Access Compliance Report

Public Rights-of-Way

Intersection ID: 44449	Main Street: BAYVIEW_PY	Cross Street: PRESTBURY_BV	Location: W
ADA ID: F5F190E629B1	Ramp Type: BlendTrans1	Initial Pass/Fail: Fail	Overall Compliance: No
		Severity Score: 10

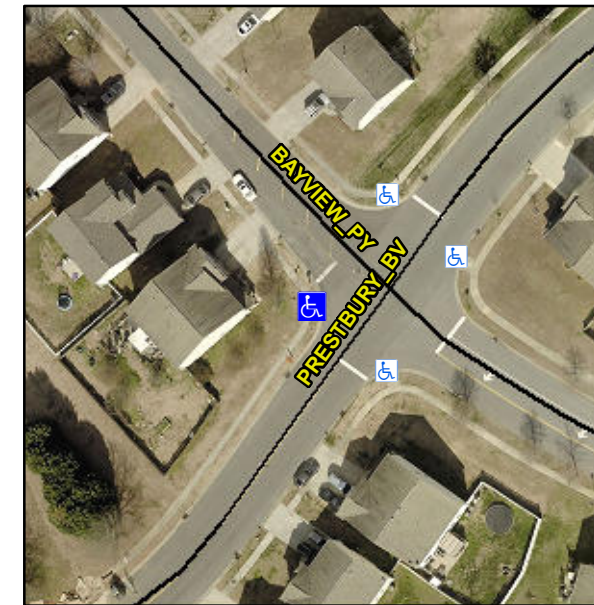
Not Found, R304.5.1, R304.5.3

Compliance	Description	Data	Compliance	Description	Data
N/A	Ramp Length (in)	48.0	Yes	BlendTrans Slope (%)	1.6
No	Ramp Width (in)	40.0	No	BlendTrans XSlope (%)	4.2
N/A	Flare Type LT	N/A	N/A	Flare Type RT	N/A
N/A	Flare Slope LT (%)	N/A	N/A	Flare Slope RT (%)	N/A
N/A	Flare Traversable LT?	N/A	N/A	Flare Traversable RT?	N/A
N/A	Landing Length (in)	N/A	N/A	DWS Provided?	N/A
N/A	Landing Width (in)	N/A	N/A	DWS Contrast?	N/A
N/A	Landing Slope (%)	N/A	N/A	DWS Length (in)	N/A
N/A	Landing X Slope (%)	N/A	N/A	DWS Full Width?	N/A
N/A	Landing Curb? (Y/N)	N/A	N/A	DWS Offset (in)	N/A
N/A	Shared Landing?	N/A			
N/A	Gutter Ponding?	N/A	N/A	Gutter Slope (%)	N/A
N/A	Gutter Lip Ht (in)	N/A	N/A	Gutter X Slope (%)	N/A
N/A	Painted X Walk1?	No	N/A	Painted X Walk2?	No
	X Walk 1 Direction	To SE		X Walk 2 Direction	To NE
	X Walk 1 Width (in)	N/A		X Walk 2 Width (in)	N/A
	X Walk 1 Slope (%)	0.1		X Walk 2 Slope (%)	1.9
	X Walk 1 X Slope (%)	2.2		X Walk 2 X Slope (%)	4.6

N/A	Ramp inside XWalk1?	N/A	N/A	Ramp inside XWalk2?	N/A
	Road Slope (%)	1.8		Clear Space?	N/A
	Road X Slope (%)	1.8	N/A	Clear Space to XWalk (in)	N/A
N/A	Any Obstructions?	N/A	N/A	Storm Grate/Utility Hazard?	N/A
	Obstruction Type			Storm Grate/Utility Type	
		N/A			N/A
			Yes	Surface Condition? (G/P)	Good
			No	Curb Slope (%)	11.9

Remove & Replace Curb Ramp With Two New Directional Ramps or Equivalent.
